McCULLOCH SERVICE BULLETIN

NO. 1673

MODEL Pro Mac 610/650 Series DATE October 1, 1978

SUBJECT Manufacturing Changes and Illustrated Parts List (P/N 93716-R1) Update.

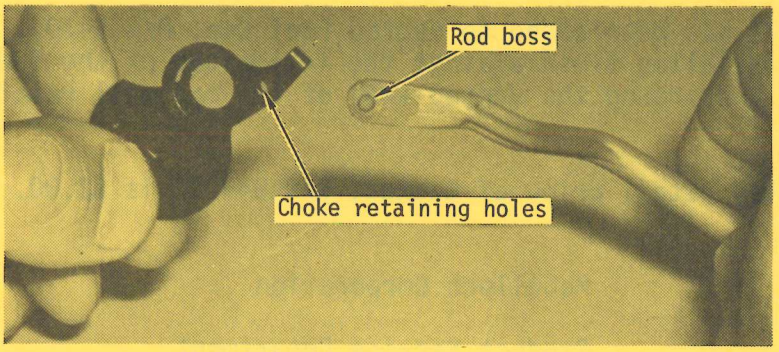
1. Figure 1, Item 15; Change the description to Kit-Clutch shoes, and the quantity from 2 to 1. The kit contains both clutch shoes.

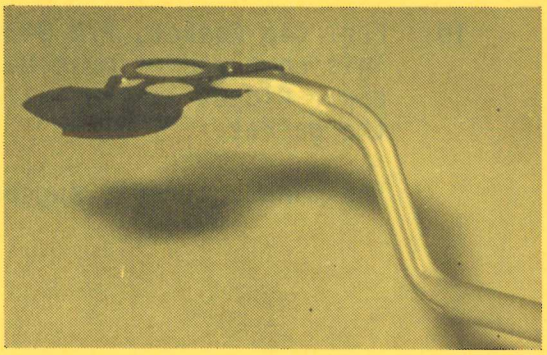
2. Figure 1, Item 47; Change Carburetor Choke, P/N 91992 to P/N 94151.

3. Figure 1, Item 54; Change Choke Rod, P/N 92001 to 94171.

NOTE: Carburetor Choke, P/N 94151, and Choke Rod, P/N 94171, are contained in Choke and Rod Kit, P/N 94482. All orders for the old carburetor choke and choke rod will be filled with this kit. When this kit is used as replacement on models originally equipped with the old components, the cotter pin and washer used as retainers must be discarded.

To assemble the new choke and rod, position the rod bosses in the retaining holes in the choke as shown. The manufacturer's suggested list price for this kit is $1.00.
